Date: January 11, 2023  
To: City of Austin Design Commission  
From: Planning & Urban Design Working Group  
Subject: Density Bonus Working Group review of 410 East 5<sup>th</sup> Street for substantial compliance with the Urban Design Guidelines  
Meeting date: December 14, 2022; 12:00 pm; Virtual Microsoft Teams Meeting  
Applicant: Leah M. Bojo- Drenner Group

The project, 410 Avenue Lofts, is located at 410 East 5<sup>th</sup> Street.

410 E 5<sup>th</sup> Street | Austin, TX

Downtown Density Bonus Program Application Package

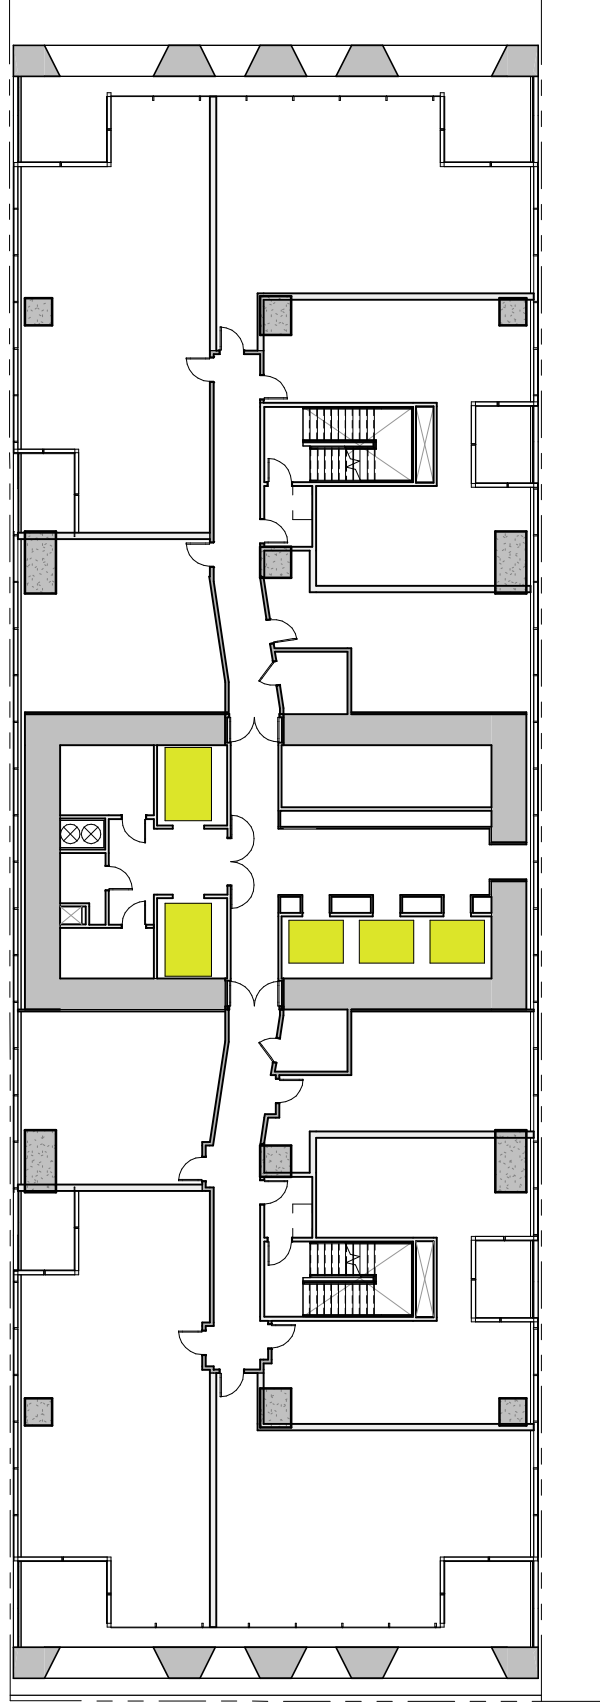
1. Protect the pedestrian where the building meets the street-  
Although this project has a minimum number of curb cuts, the two wide entrance/exits for the 8 level parking garage (many vehicles) raises concerns about pedestrian safety at street level. Some type of change in paving pattern or color and signage would warn pedestrians that they should be cautious of approaching vehicles. Project partially complies with this Section.

"The Building and Site Plans need more labeling, especially street names. Only one drawing was properly labeled but it did not include street names".

South Elevation

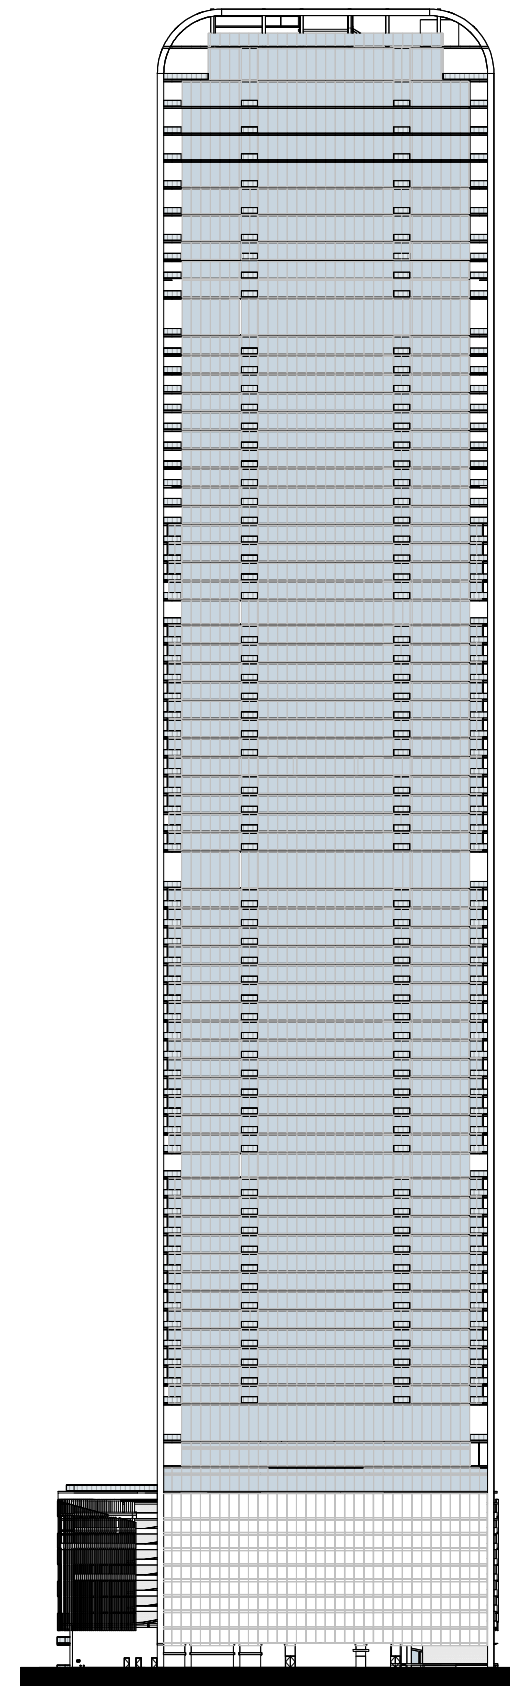
11. Screen mechanical and utility equipment-  
Equipment is either screened and/or within building envelope. Project complies with this Section.
12. Provide generous street-level windows-  
For such a large footprint, street-level windows are limited. Some transparency (visual connection) between the water-feature courtyard and building interior (south elevation) would be nice as this is the major façade. Project partially complies with this Section

13. Install pedestrian-friendly materials at street level-  
The street level materials appear to be pedestrian friendly, but more glazing would better connect the building to the pedestrian activity. Project partially complies with this Section.

3. Accentuate primary entrances-  
The illustrations (elevations and renderings) do not clearly convey that primary entrances are well accentuated. Project does not comply with this Section.

6. Create quality construction- Project complies with this Section.
7. Create buildings with human scale-  
The illustrations (elevations and renderings) do not clearly convey a sensitivity to human scale. Some close-up vignettes active areas would help. Project partially complies with this Section.
